Title: Refrigerator Door Misalignment

Detail: The purpose of this service bulletin is to provide the service instruction and part change in order to improve door alignment on refrigerator by adding a washer to level a door.

2.2 Change/Installation

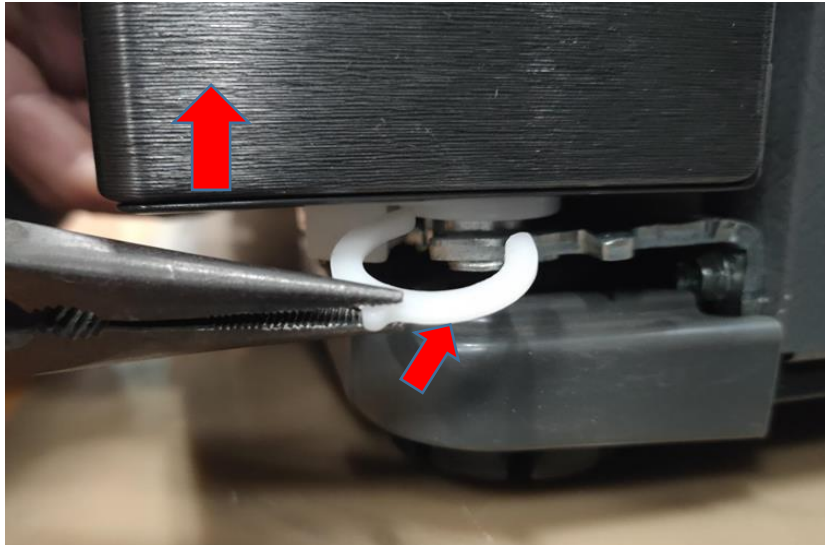
The Refrigerator VCZ and FZ door are not leveled.

If the level gap is obvious larger than 2 mm, the recommended washer 2.0 mm thickness can be applied.

Or if the level gap is less than 2.00 mm, the washer thickness 1.0mm can be applied.

2.2.1 Lift the lower side door and insert the Door Levelling Washer in between gap Busher and Endcap

2.2.2 After inserting the washer, visual check by observing both doors, the gap should be less than 1.5 mm. If necessary, the washer should be selected either 1.0 mm or 2.0 mm to be adjusted.
